Beacon Falls

Burton Road

– Road Safety Audit

August 24, 2016

Figure 14. Trim Vegetation

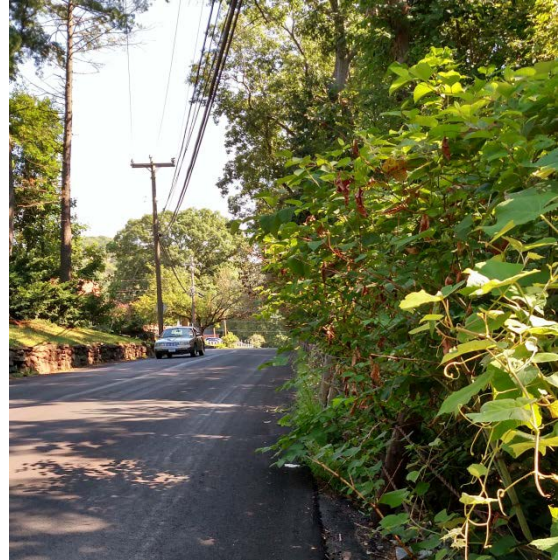
- Vehicles turning left onto Maple Avenue from Burton Road take the turn at high speeds.
- Burton Road has steep grades on either side.
- Tree branches block sight lines along Burton Road and low growing vegetation impedes the shoulder where there is sidewalk (Figure 10).

1. Paint a crosswalk across Town Hall Driveway (Figure 13).
2. Clear vegetation to improve sight lines (Figure 14).
3. Install slow for curve, curve ahead or S-curve signs on the south approach.
4. Where there is no sidewalk, install "walk on the left" signs (Figure 15).
5. Convert Maple Avenue to stop controlled and add left and right turn lanes.

Figure 17. Short Term Recommendations

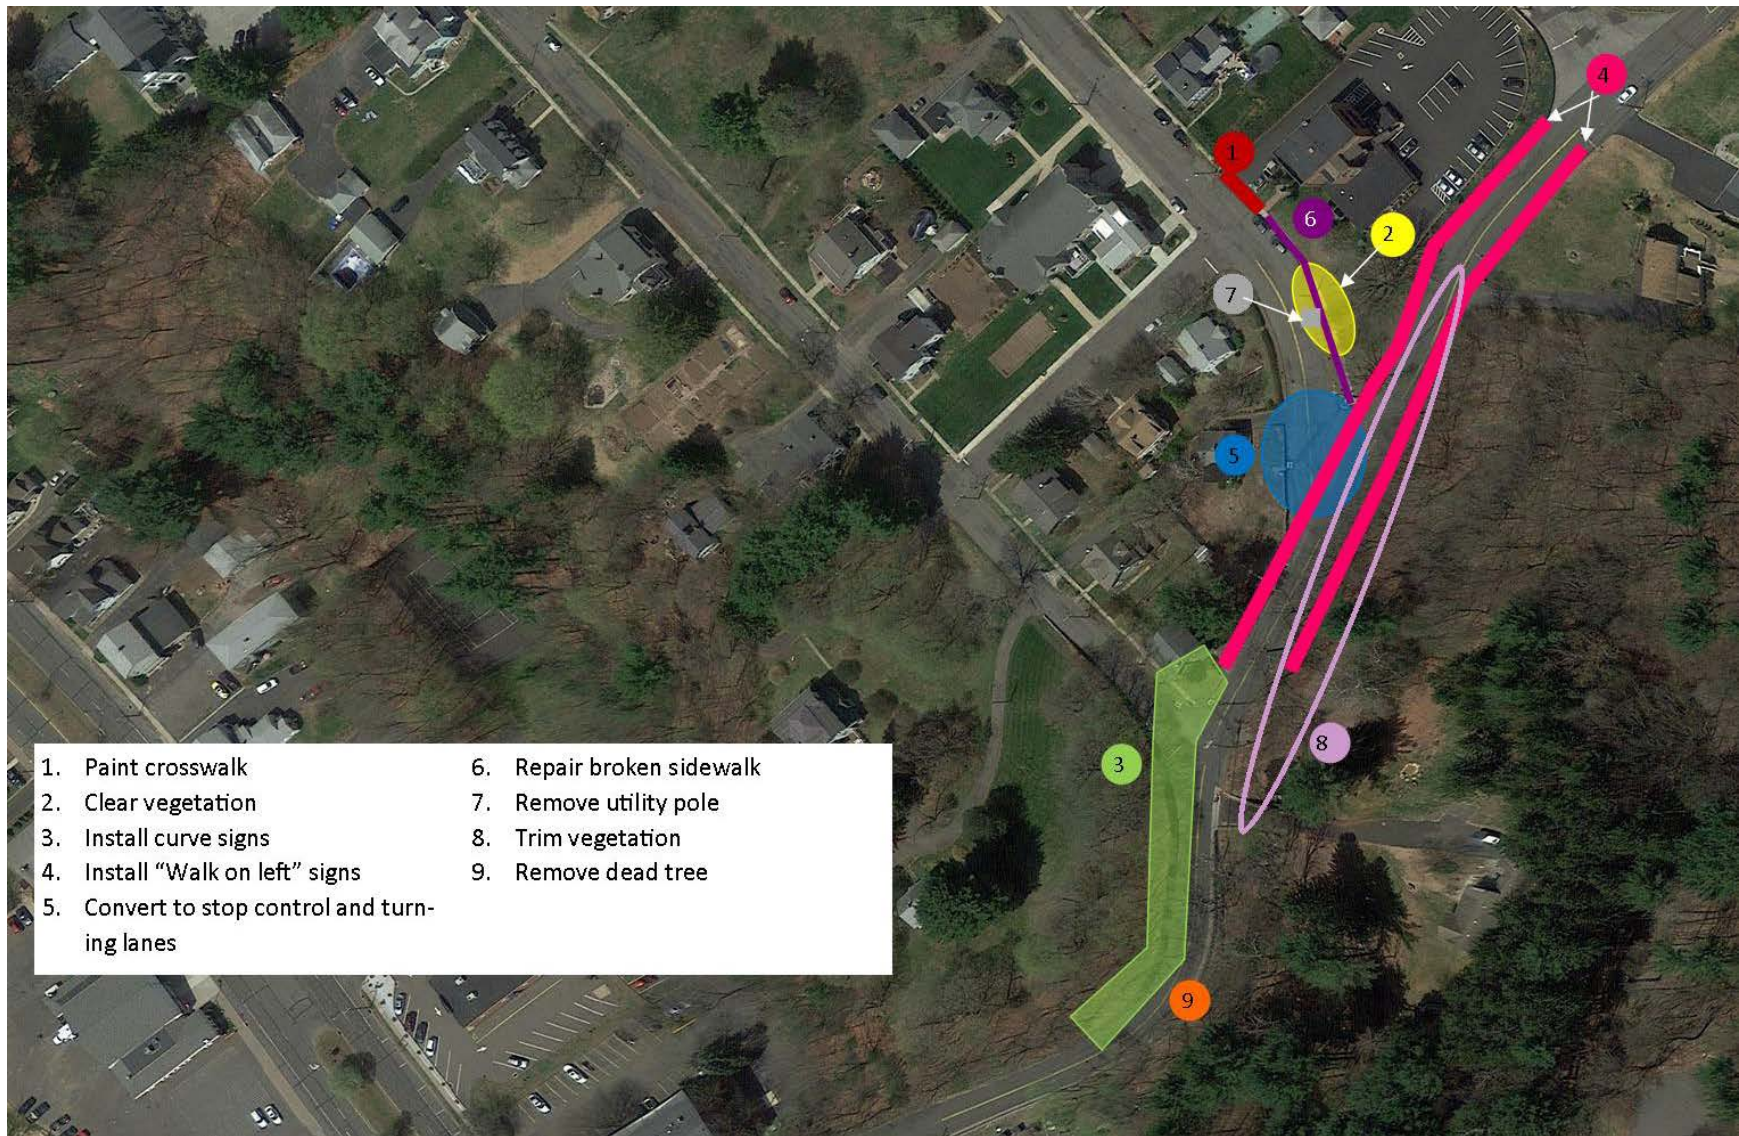
- Converting Maple Avenue to a stop controlled intersection with left and right turns would slow vehicles down.
- All crosswalks should have proper advanced warning signs.
- Heaving of the sidewalk has become a serious issue and the wall needs to be stabilized.
- When Maple Avenue and Wolfe Avenue are reconstructed, five foot sidewalks should be installed with a snow shelf. The sidewalk should be pushed against the right-of-way. The sidewalks should be upgraded with ADA compliant ramps and tactile warning strips.
- Clearing vegetation on Burton Road will help improve the sightline. Signage needs to be added to alert motorists that pedestrians might be along Burton Road.

6. Repair broken sidewalks on Maple Street in front of the Town Hall.
7. Remove the unused utility pole in the snow shelf which is rotting.
8. Trim the vegetation that blocks the sidewalk and the shoulder.
9. Remove the dead tree with branches leaning against the utility wires (Figure 16).
10. Replace faded and worn out signs.

Figure 18. Mid Term Recommendations

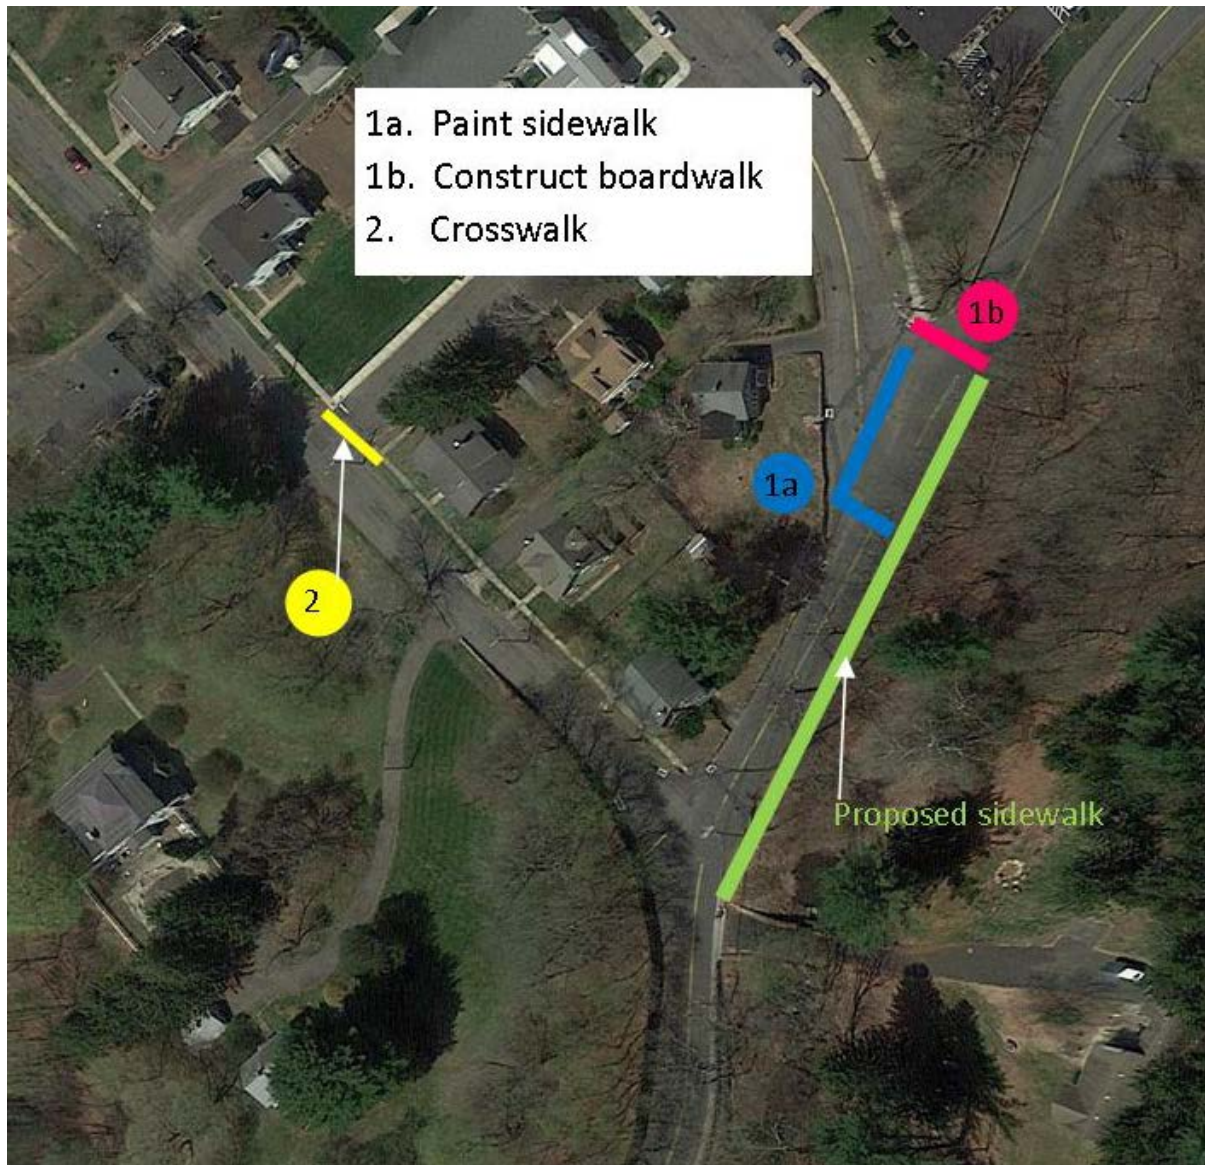
- If the sidewalk were to extend through the existing town hall driveway, then parallel parking along the building would have to be eliminated unless a second entrance was created. This would allow for narrowing the driveway. The walkway would be best situated against the fence.
- A board walk should be used along Burton Road where there are wetlands in order to limit environmental concerns. The walkway should include a positive barrier between it and the road.
- There are two options to connect the existing sidewalk to town hall. The first option would be to square off Maple Street and extend the sidewalk to the south side of Maple Avenue, install a crosswalk across Burton Road on the south side and then one across Maple Avenue. The second option would be to extend the sidewalk to the north side of Maple Avenue and cross there. This option would have a higher cost due

to the extended boardwalk. For both options, a flashing beacon can be added in the future across Burton Road if the volume increases.

1. Evaluate the options to connect Burton Road to Maple Avenue and determine which option is best for the crosswalk.
 - a) Option 1 – across the south side of Burton Road and Maple Avenue.
 - b) Option 2 – across the north side of Burton Road.
2. Paint crosswalk across and add ramps and tactile warning strips to Century Avenue.
